SEAT HEIGHT ADJUSTMENT PROPOSAL 1

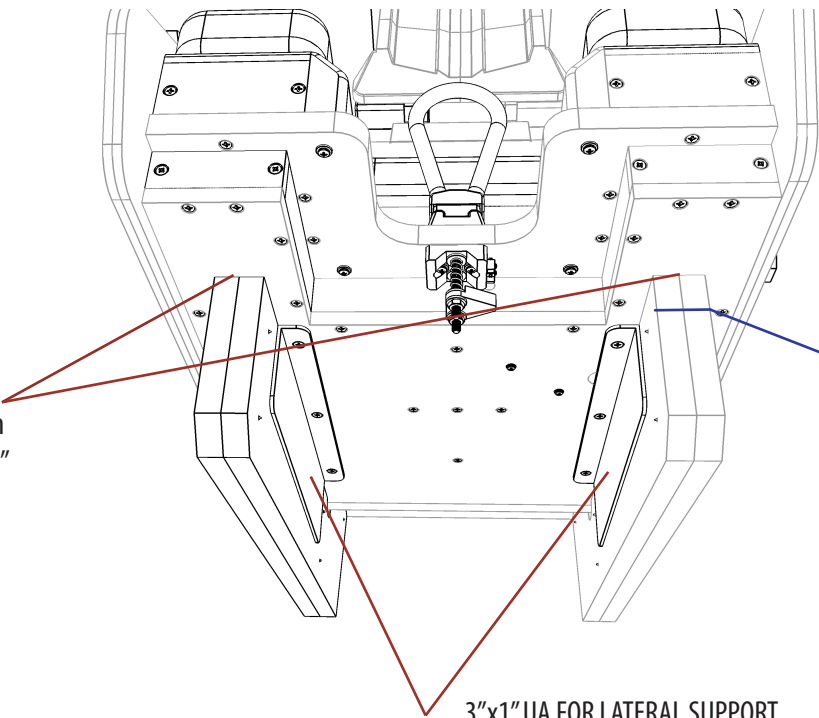
2.4" gap between seat back top and
lower head rest block.

Seat frame can be trimmed
if seat needs lowering.

MDF packing between
bucket and frame to 2"
max.

3"x1" UA FOR LATERAL SUPPORT
